**EnergyAustralia**

# State Environment Protection Policy (Waters) Review

## EnergyAustralia - Submission on the proposed State Environment Protection Policy (Waters)

FIGURE 1: SURFACE WATER SEGMENTS

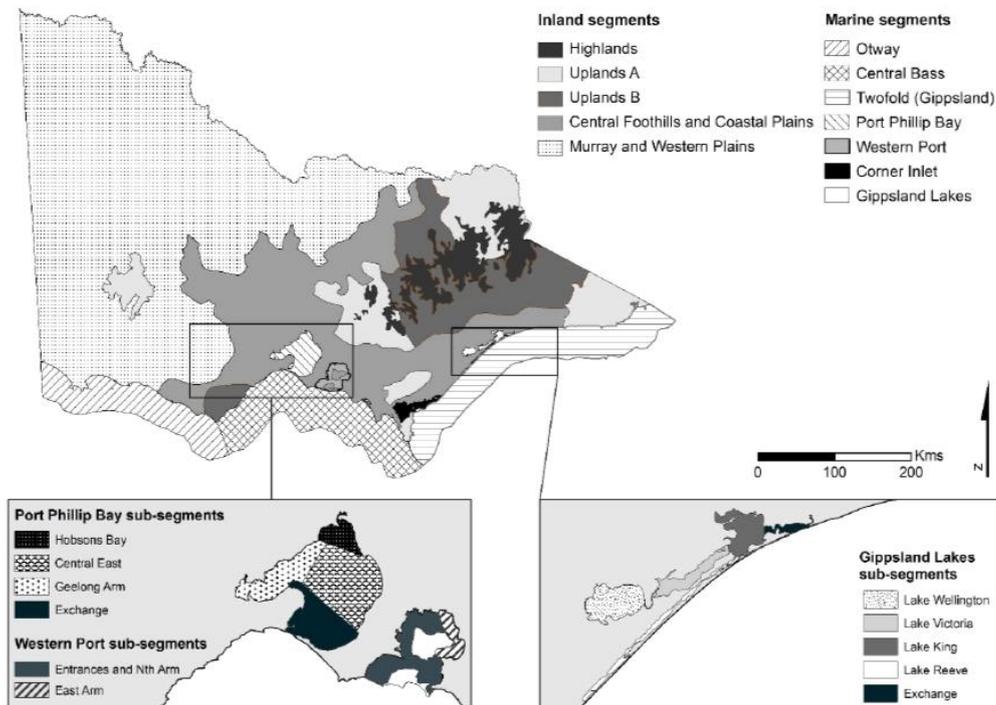
As indicated in section 2.1 above, the Proposed SEPP does not clearly set out the segments which purport to categorise Victoria's surface water ecosystems. To this end, Figure 1 under Schedule 1(2) of the Proposed SEPP (extract below) is intended to illustrate the segment boundaries, but is not specific enough to allow confident analysis of such boundaries. Understanding the relevant segment boundaries is critically important to understanding what environmental quality indicators and objectives apply to respective surface waters.

There is uncertainty regarding precisely which segment of the environment the Yallourn mine and power station falls within for the purposes of the Proposed SEPP, given the vague plans and descriptions set out under Schedules 1(2) and 1(3).

In EnergyAustralia's case, it is not entirely clear where the Yallourn mine and power station lies with respect to the boundary between the "Uplands A" and the "Central Foothills and Coastal Plains" segments, when considering its location against the map and definitions set out under Schedules 1(2) and 1(3) of the Proposed SEPP. Should the "Central Foothills and Coastal Plains" be the relevant segment which encompasses the Latrobe Valley, the relevant sub-section must then be further delineated. It is presumed that the Yallourn mine and power station falls under the "Lowlands of Yarra, Western Port, Latrobe, Mitchell, Tambo and Snowy" sub-segment. However, significantly different environmental indicators and objectives would apply if this is misinterpreted and in fact another sub-segment applies.

It is suggested that a more detailed and interactive map be developed for the purposes of the Proposed SEPP which specifically delineates the relevant segment boundaries. It would preferably include roads, landmarks, city and townships for reference.

Further, the definitions for the relevant segments should be more descriptive, and should refer to particular geographical parts of surface water catchments, roads, landmarks and townships as reference points.
